The Displacement Test as an Alternative to the 60 mm Gap Requirement
Submitted by the United States

Figure 1

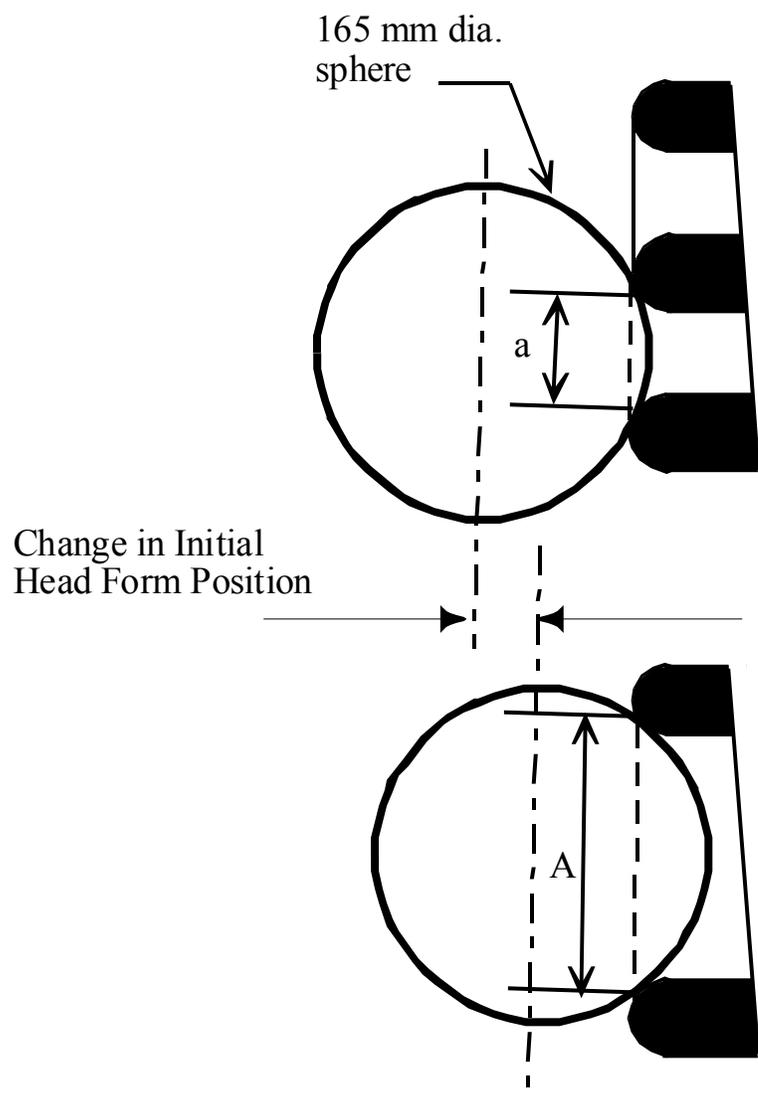
For example, there are two head restraint designs with everything equal except the gap size. The first has gap “a” that is less than 60 mm and the second has gap “A” that is greater than 60 mm. The figure below shows that a head restraint with a larger gap will allow more head form displacement, from an initial position forward of the head restraint, than the head restraint with the smaller gap. After head restraint contact and the 373 Nm moment is applied, the head form displacement is the same for both gaps.

To accept the displacement test as an alternative to the 60 mm maximum gap requirement in the gtr, they both must produce equivalent results. If we are trying to limit an occupant's head displacement into the head restraint, the 60 mm maximum gap requirement appears to be more stringent than the displacement test requirement.

Have we misinterpreted the ECE requirement? How does the 60 mm gap limit and 102 mm displacement/373 Nm force requirement applied at the gap offer equivalent levels of safety?
